CONSULTANT ADVICE NOTICE

PROJECT: 480 Swan Street, Richmond
Reference: IMP191103CAN02F01.docx

Subject RESPONSE TO COUNCIL RFI & DoT CONDITIONS

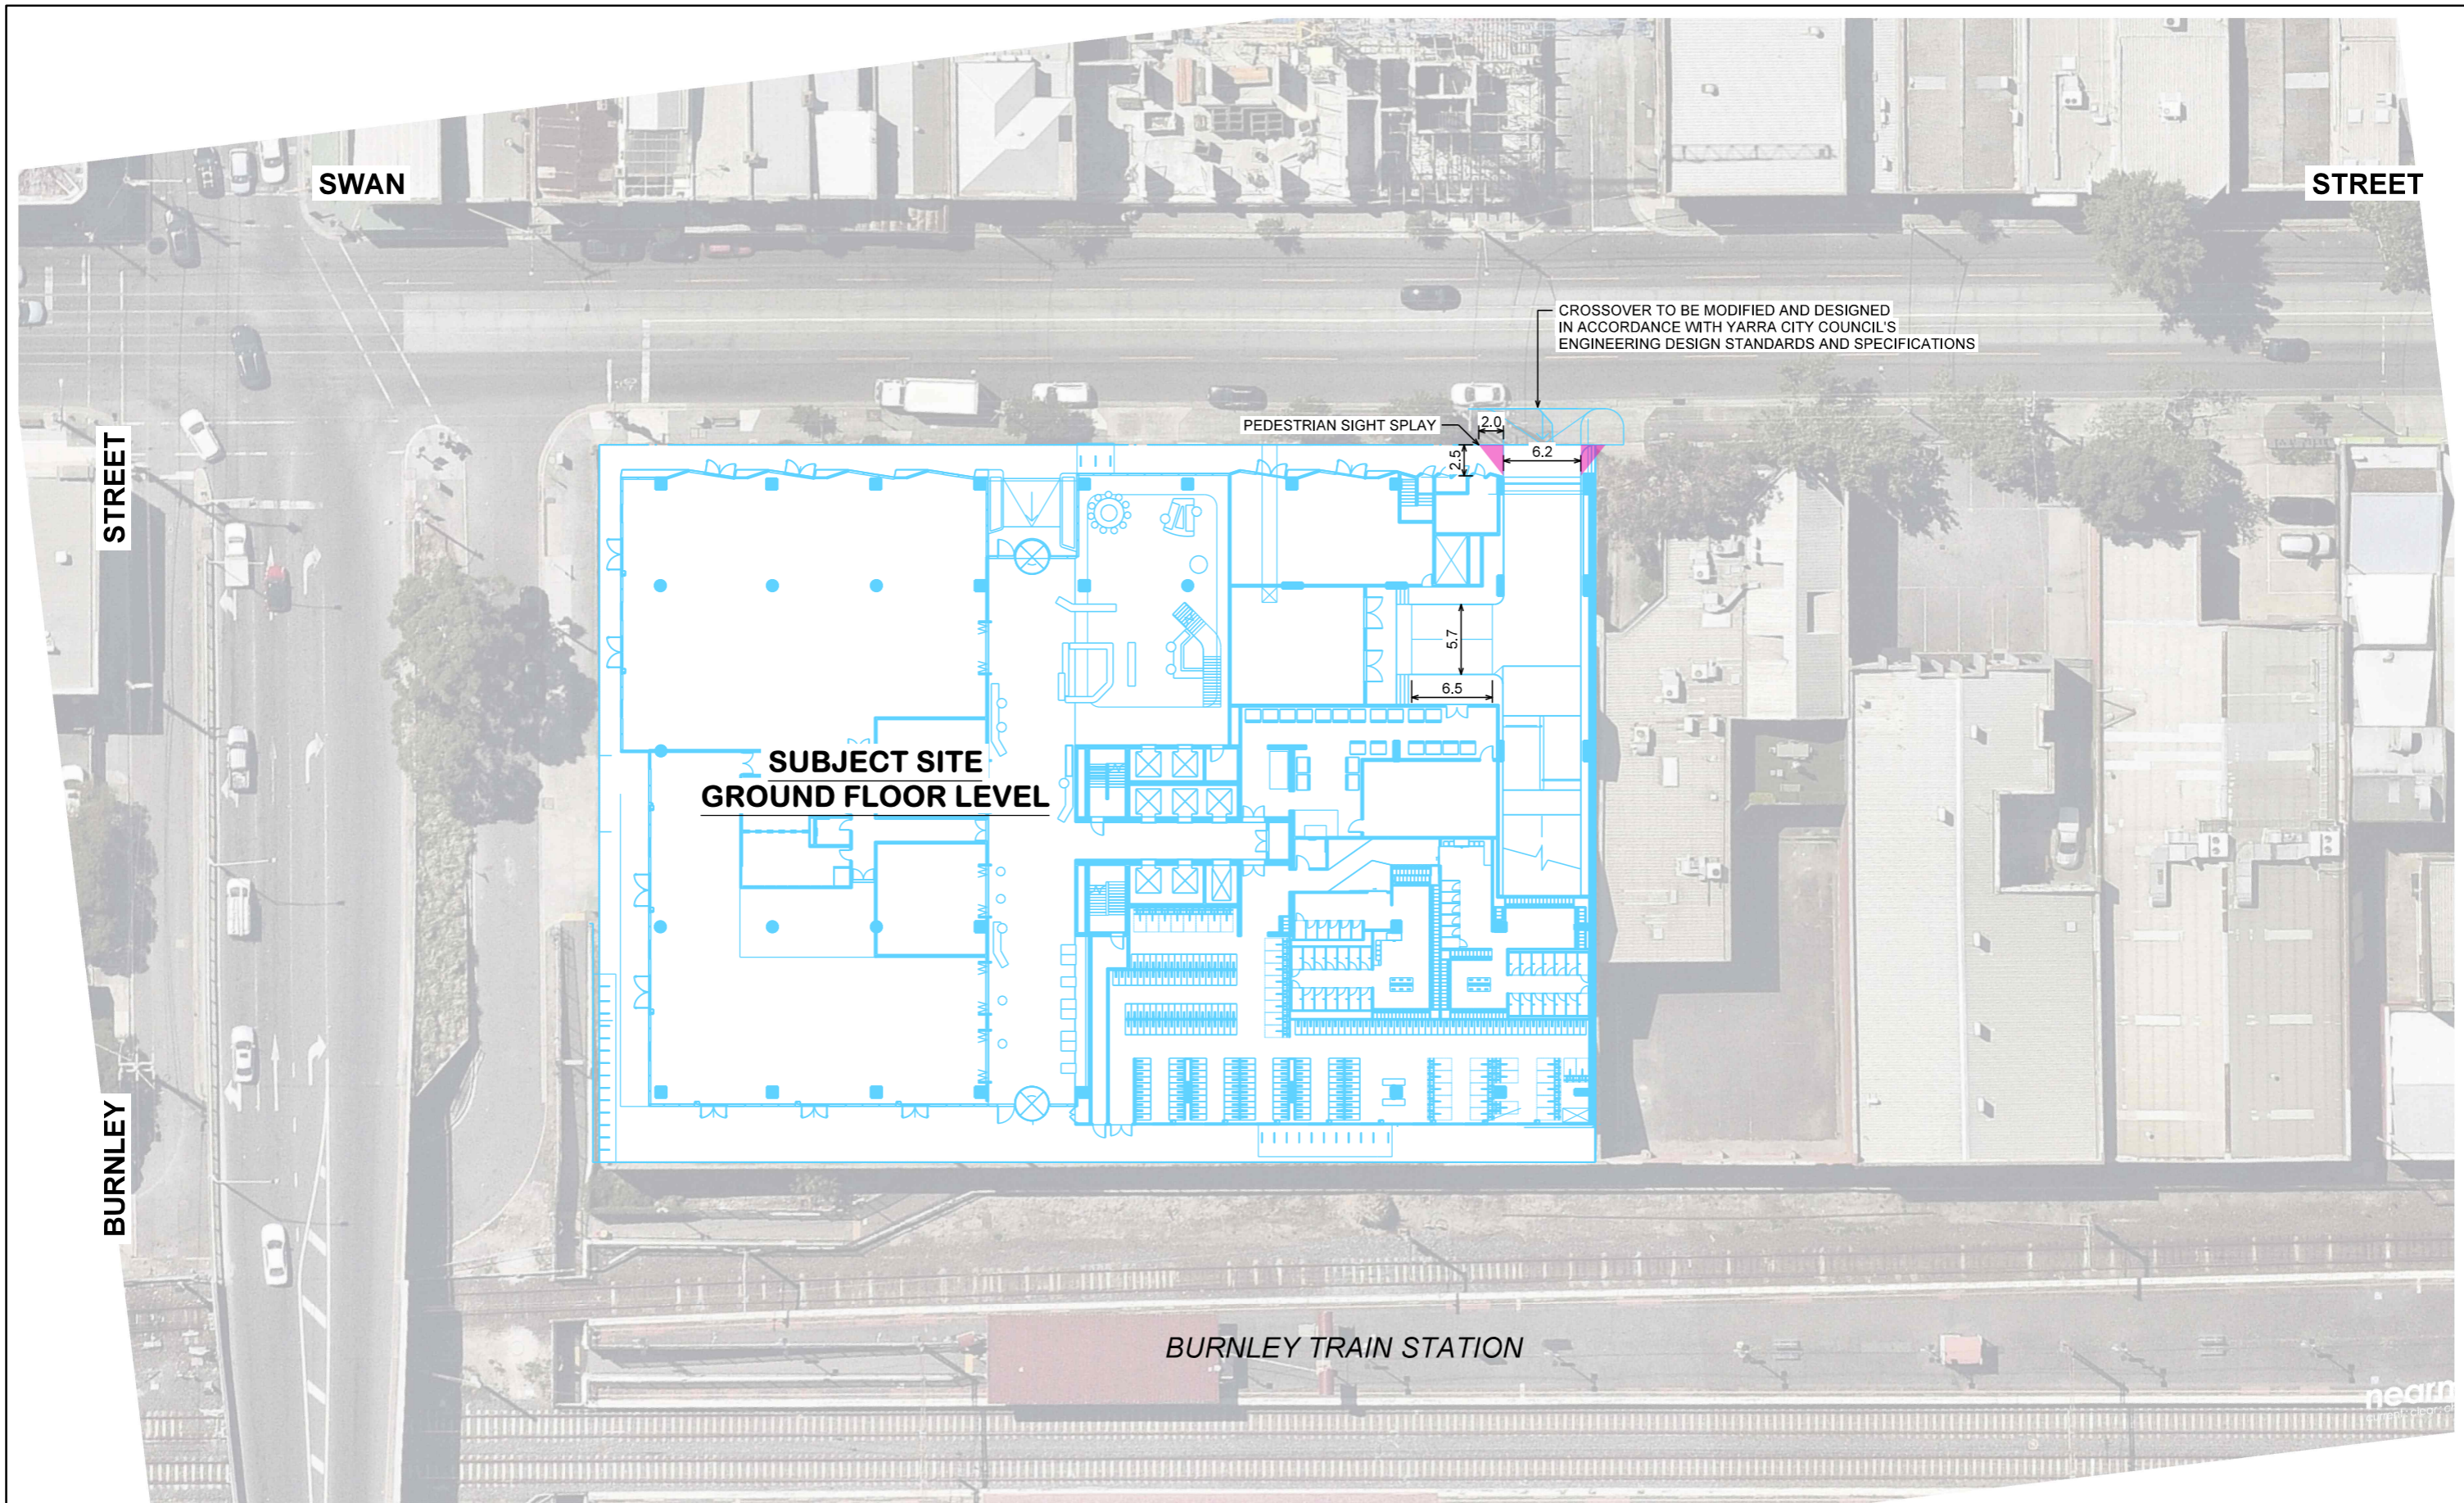
a) the installation of signs, line marking, splitter island and associated road works permitting only 'left turn in' and 'left turn out' vehicular access from Swan Street (informed by the Road Safety Audit);

As discussed above and subject of course to the findings of an independent road safety audit, we consider that a suitable balance between performance and safety would be to only restrict right turn movements out, with all other movements permitted i.e. left in / right in/ left out.

If such a recommendation were put forward in the Road Safety Audit, how would this be addressed noting the specificity of Condition 1a in relation to permitting only 'left turn in' and 'left turn out' vehicular access?
